610.14692-L01-v1.0 Response to FRNSW 20170301.docx

Mortdale Fire Safety Study Response to FRNSW

Resource Recovery Facility

Mortdale

Figure 6

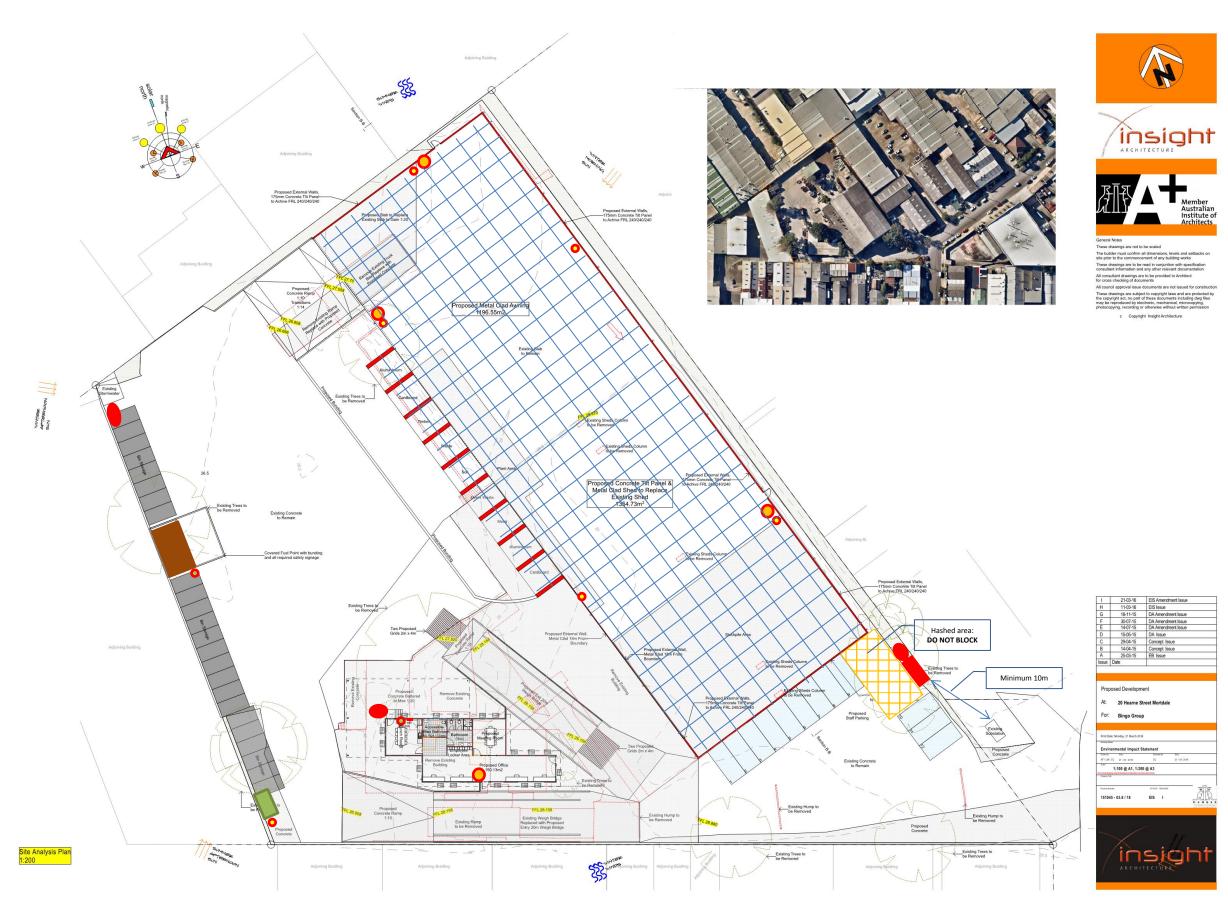
- The location of the booster hydrant; and
- The location of the attack hydrants.

The booster hydrant needs to be located at the entrance of the site. The proposed location was too far into the property and this has caused concern with FRNSW. The solution will be to relocate the booster hydrants to the front entrance. It is noted that some difficulties are present with this design due to the Electrical sub-station also located at the entrance of the site.

The attack hydrant can also be relocated at the request of FRNSW. It is noted that in accordance with AS 2419.1 - 2005 the length of hose from the attack hydrant to the location where a fire is to be fort must not exceed 60m (+10m of spray). This will limit the location of where the attack hydrant can be placed on site in order to reach the far side of the shed.

A revised plan showing alternative location for the booster and the attack hydrants has been attached.
